SERVICE BULLETIN

APPLICABILITY: 2019-24MY Forester NUMBER: 07-218-23R

SUBJECT: Genuine Alternative Battery Replacement

REVISED: 12/21/23

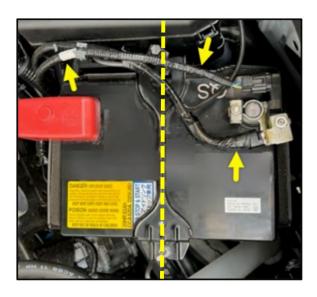
STEP 4: Install the NEW battery cover (p.n. 82123AN000) to the alternative replacement battery. Confirm the bottom of the cover is aligned flush with the bottom of the battery.
